### **ADDENDUM # 6 Bid 20C6, Waverley Elementary School - New Construction**

## **ADDENDUM NO. 6**

RE: **WAVERLEY ELEMENTARY SCHOOL REPLACEMENT**

1 SECTION  
S3.4 1" = 1'-0"

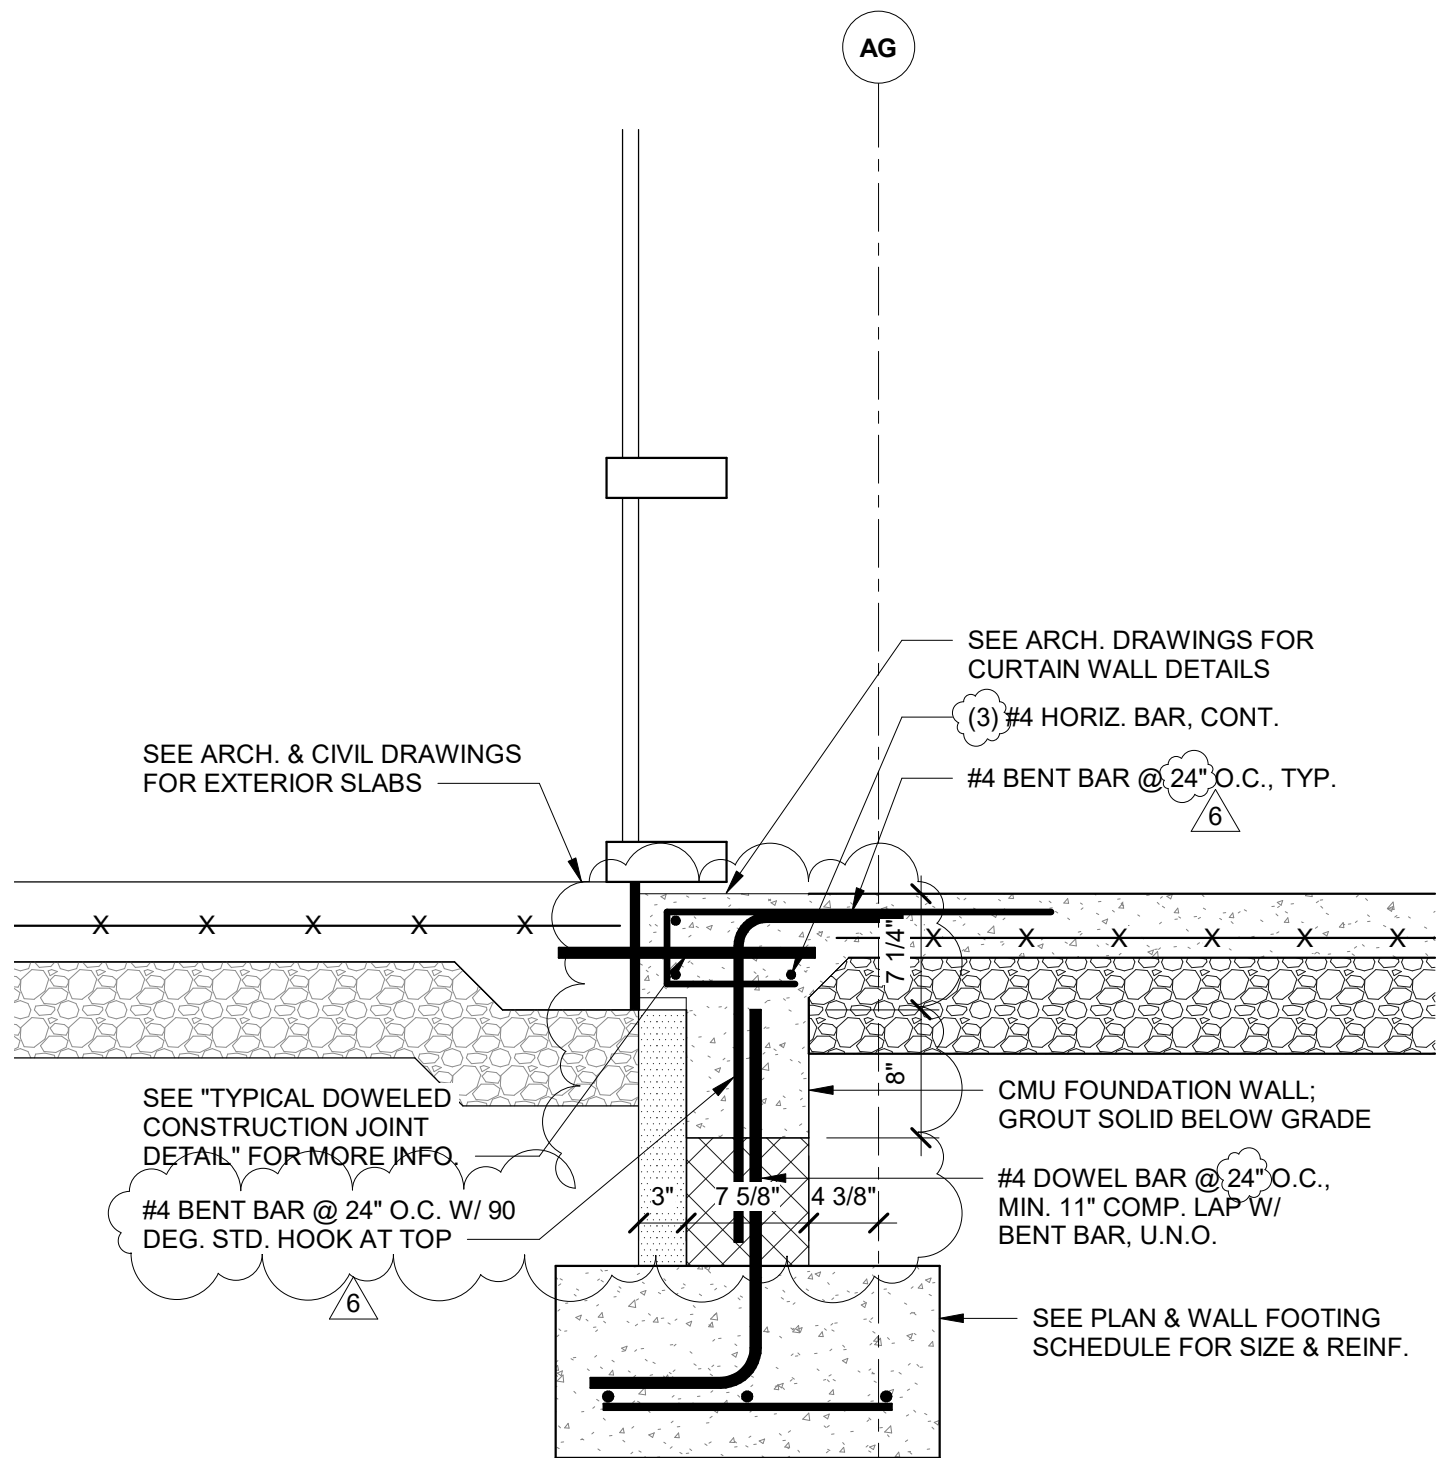
9. **REVISE** Drawing Sheet S3.4 – FOUNDATION SECTIONS; ADDENDUM #3, (Revision dated 04/01/2020).
  - **REVISE** detail 1/S3.4 per Sketch ADD6.3 included with this addendum.

7 SECTION  
S4.5 1" = 1'-0"

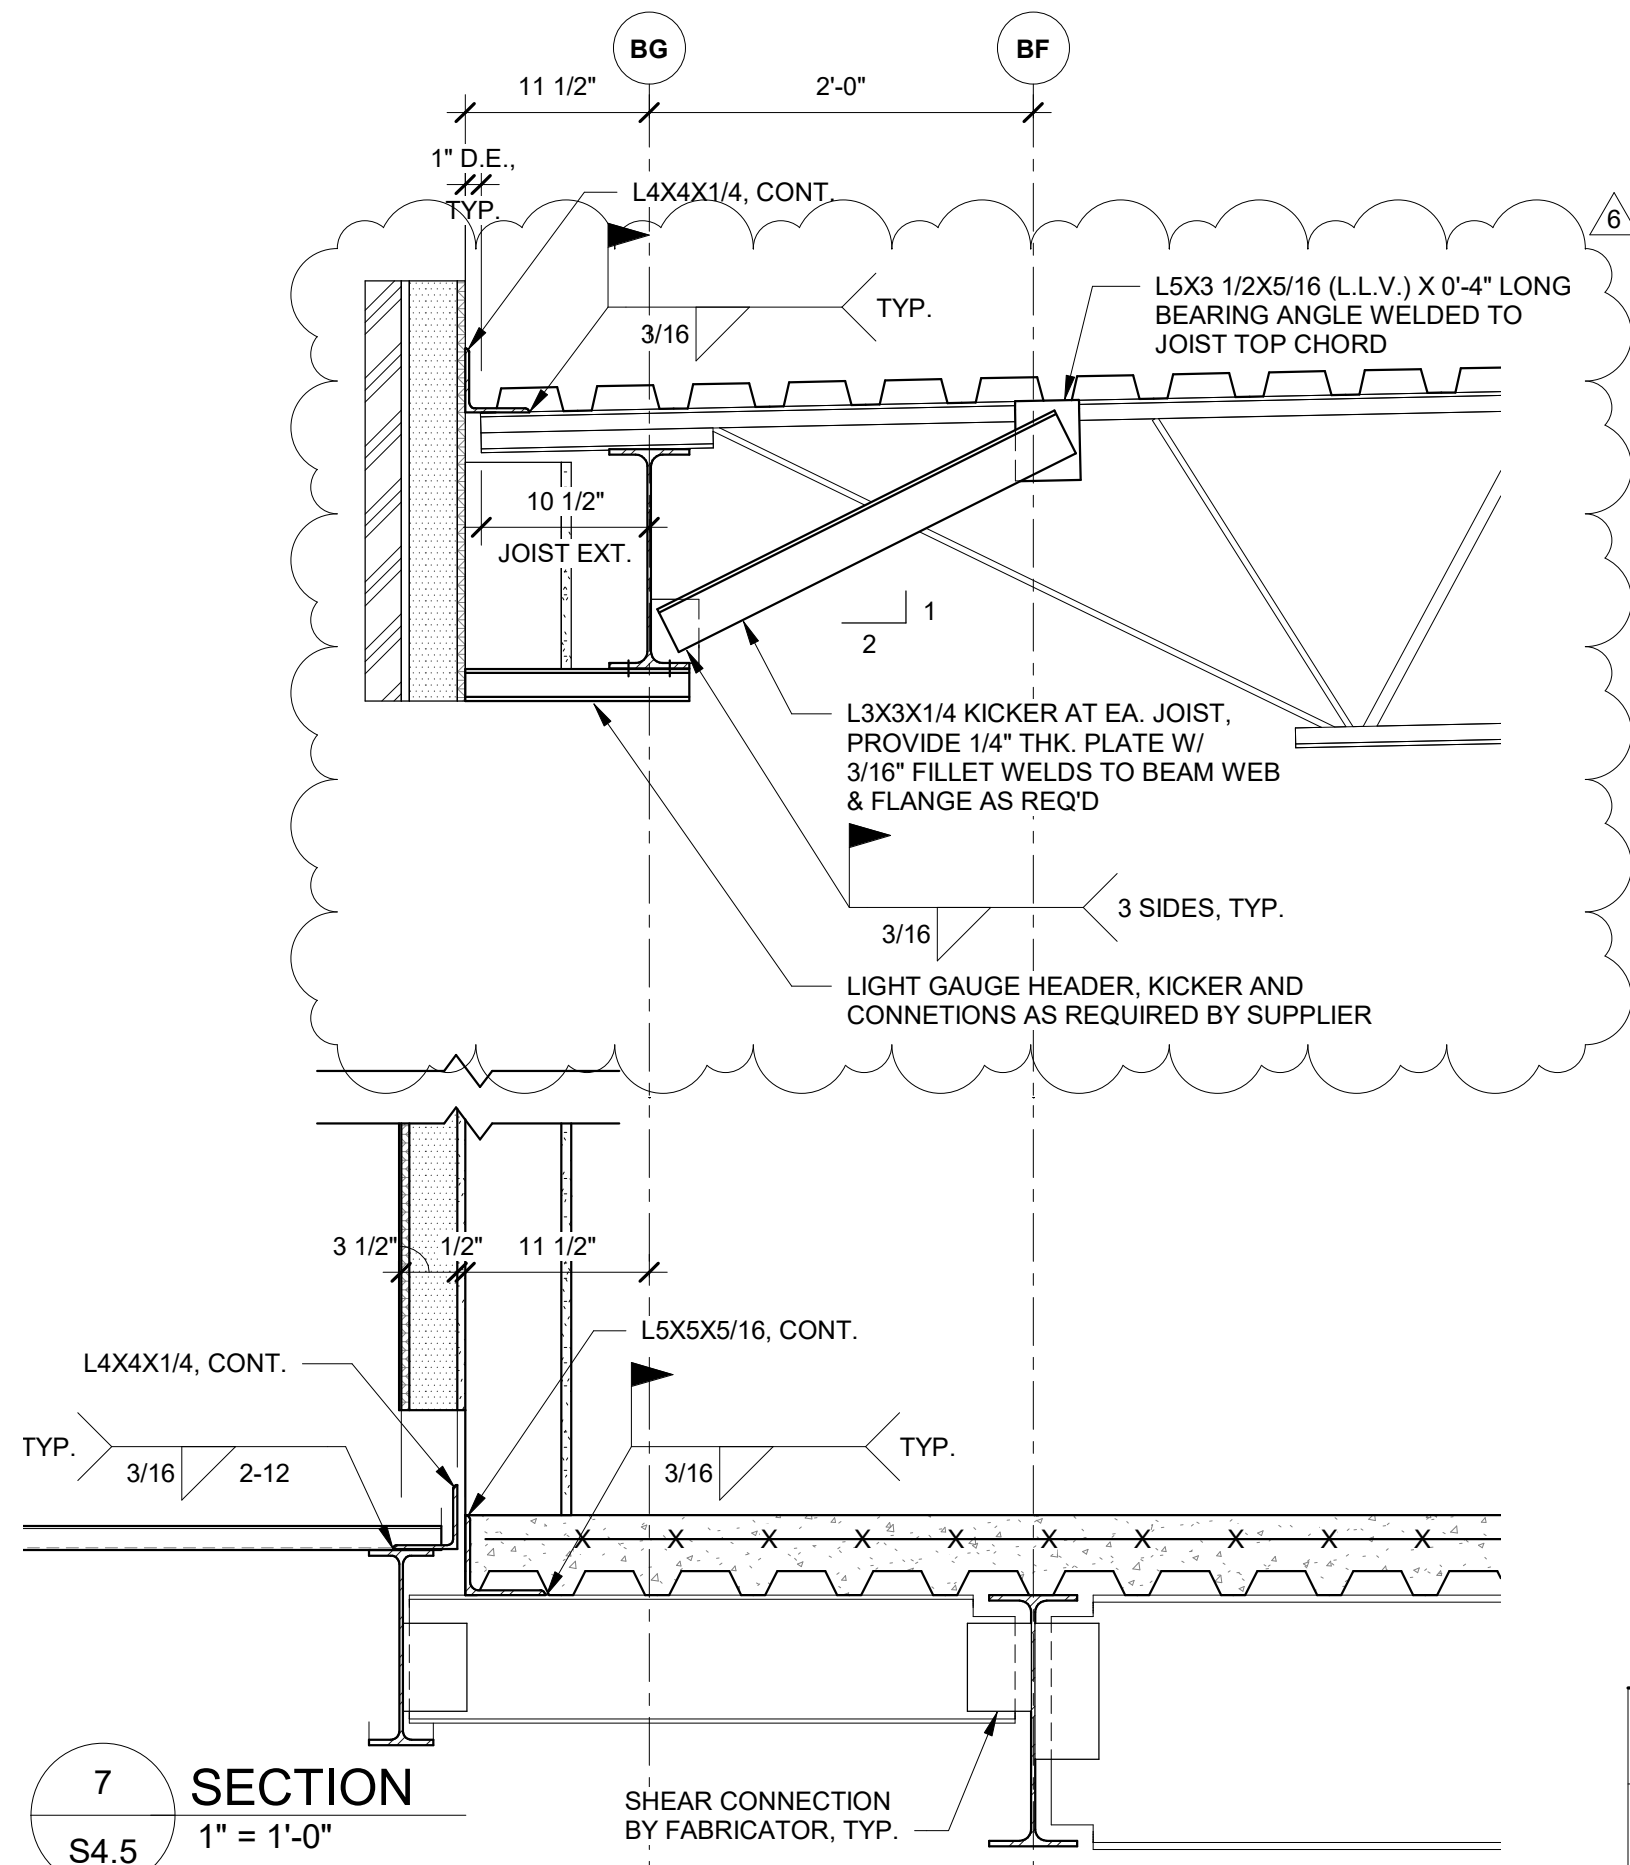
- **REVISE** detail 7/S4.5 per Sketch ADD6.5 included with this addendum.
  - **ADD** detail 9/S4.5 per Sketch ADD6.4 included with this addendum.
  - **ADD** detail 10/S4.5 per Sketch ADD6.5 included with this addendum.

1 AREA F - NORTH  
A3.1 1/8" = 1'-0"  
FROM 1 / A1.6

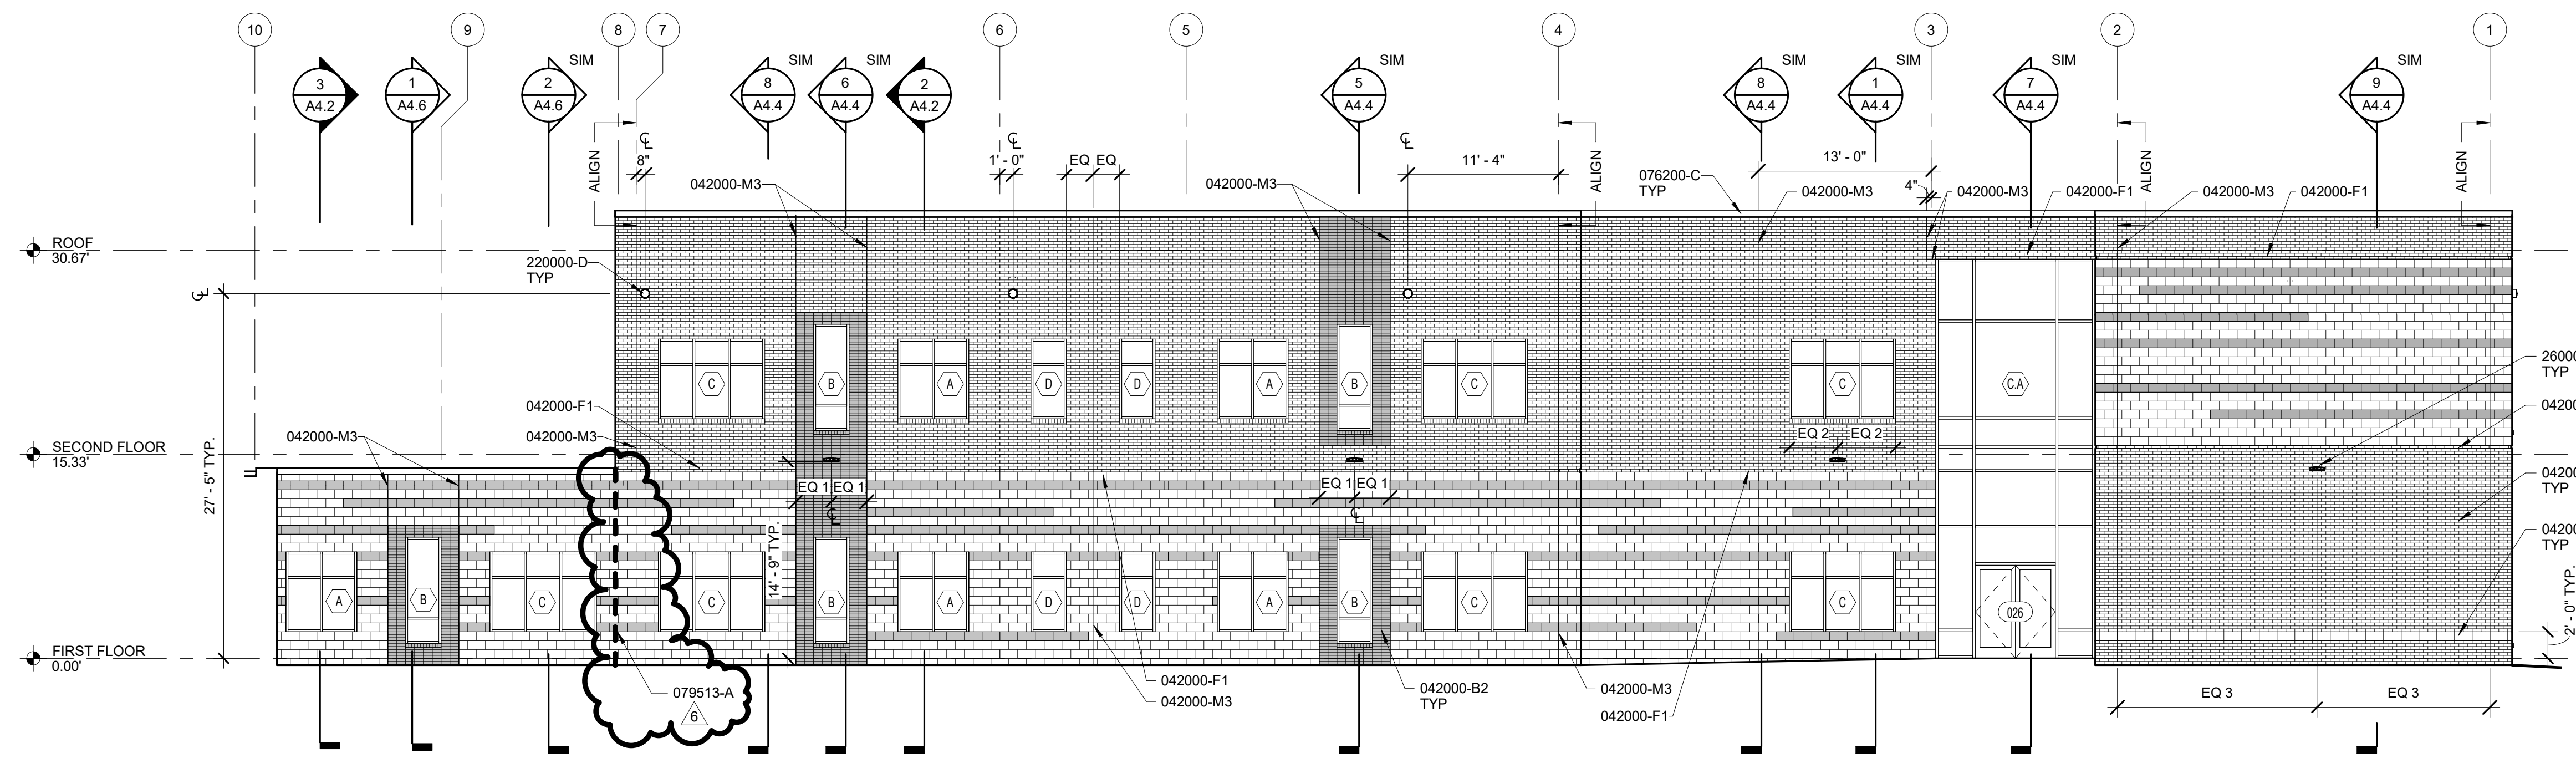
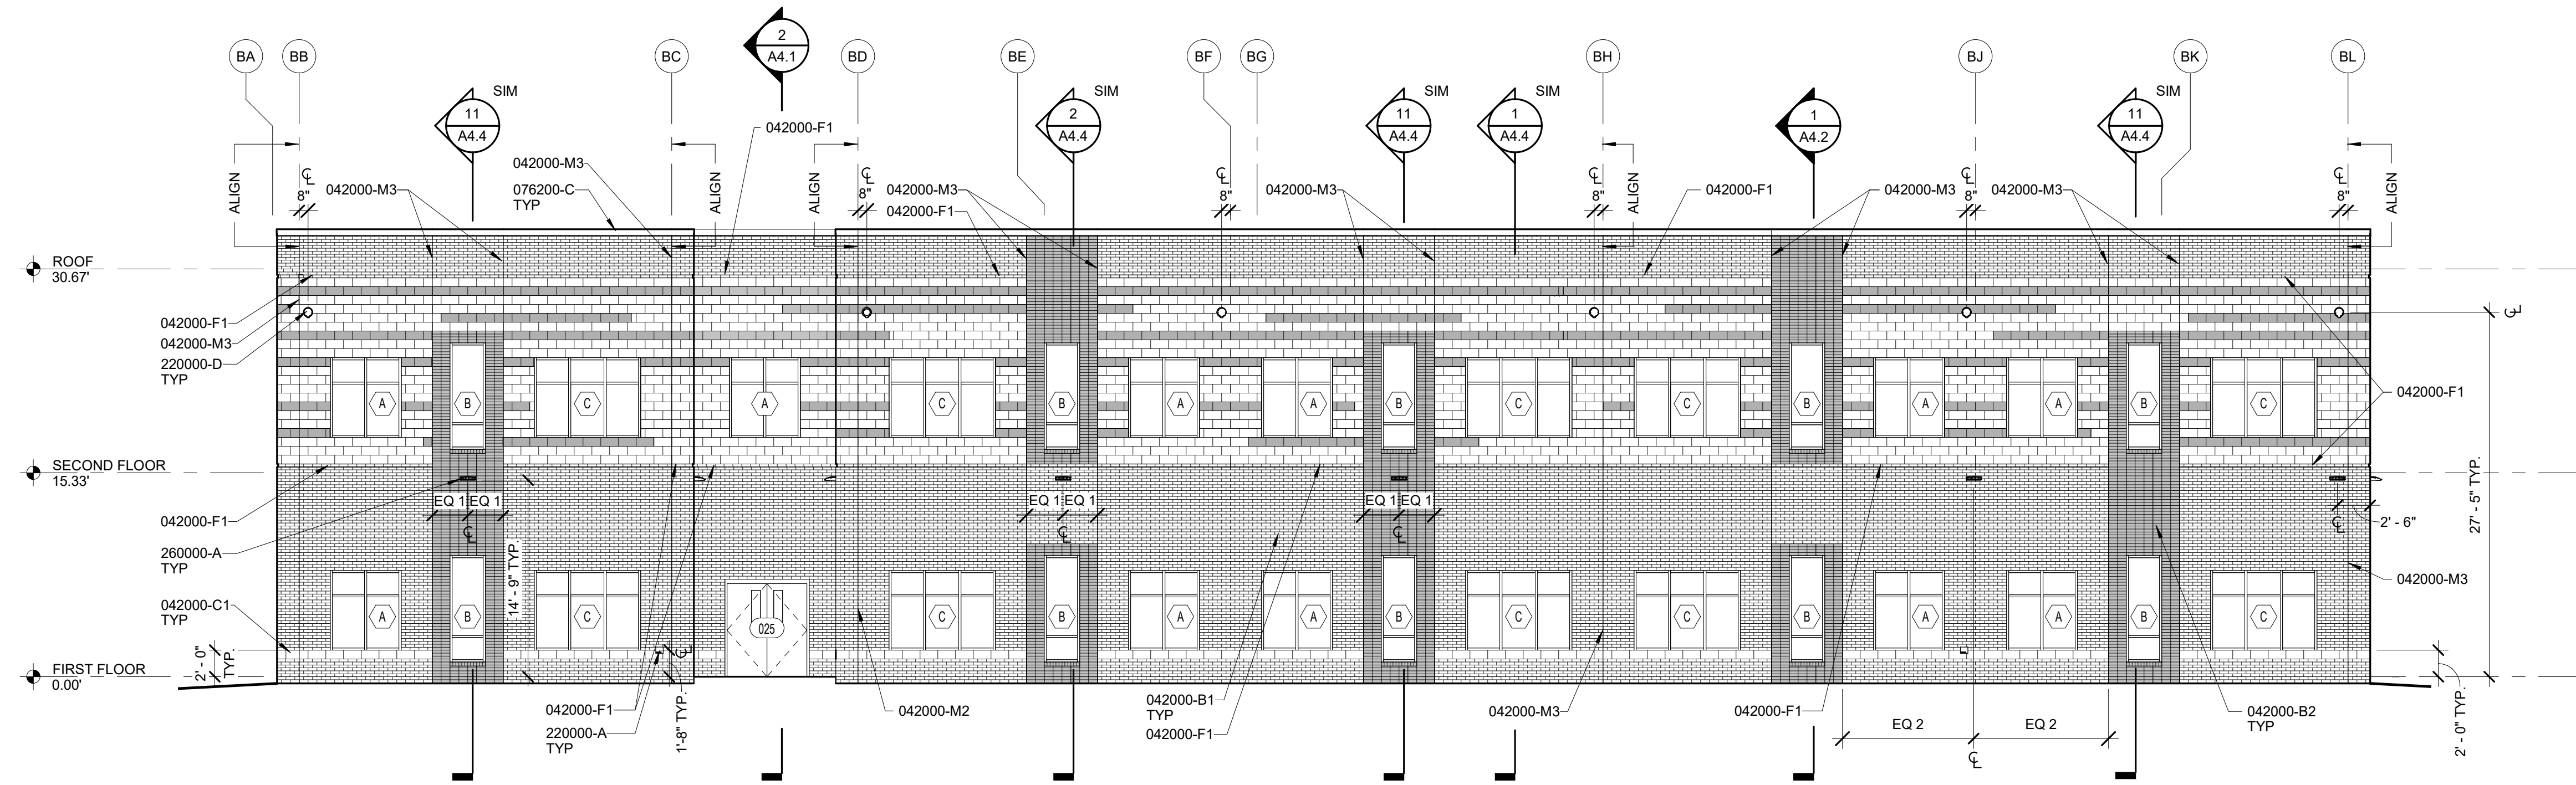
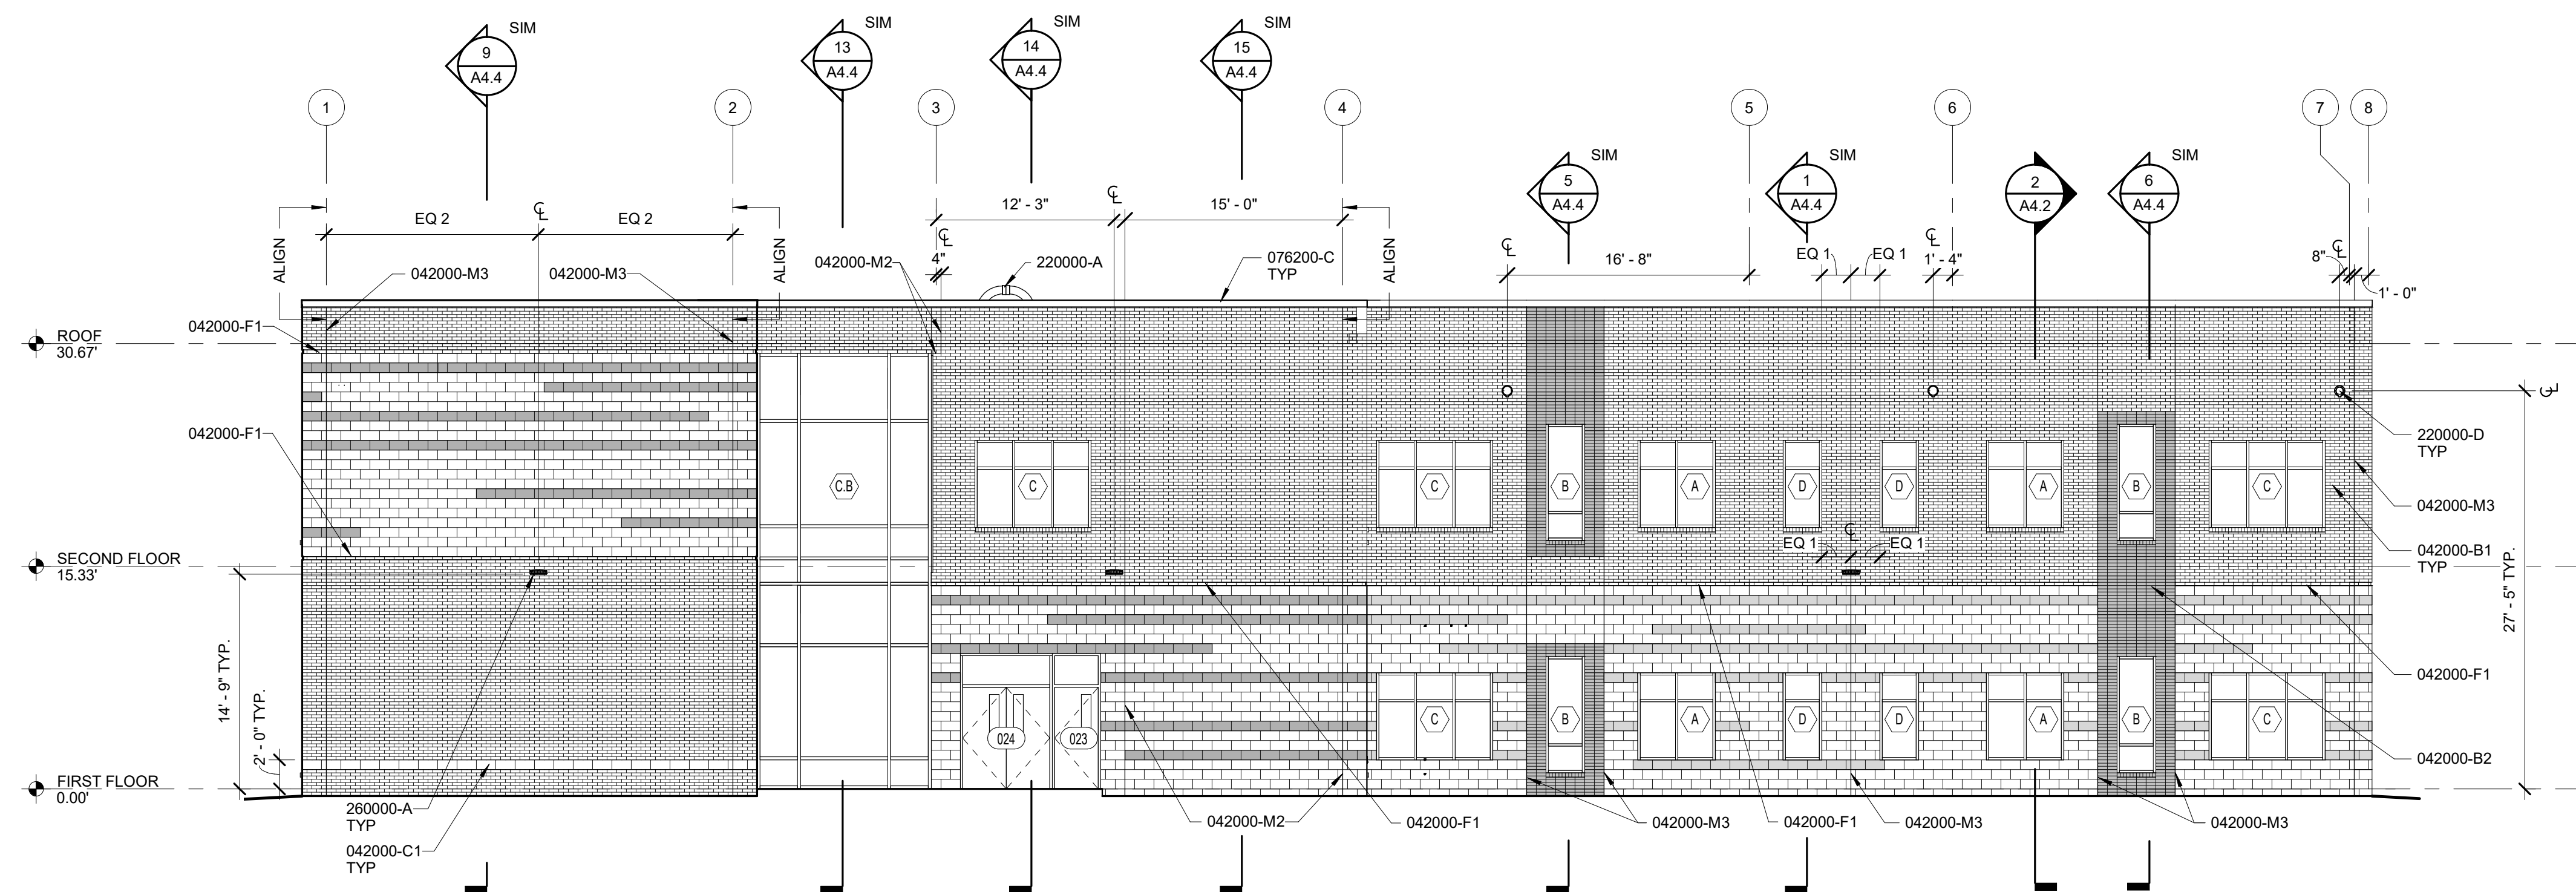
20. **DELETE** Drawing Sheet A3.1 – EXTERIOR ELEVATIONS; Issued for Bid, dated 03/06/2020; **ADD** Drawing Sheet A3.1 – EXTERIOR ELEVATIONS; ADDENDUM #6 (Revision dated 04/22/2020).
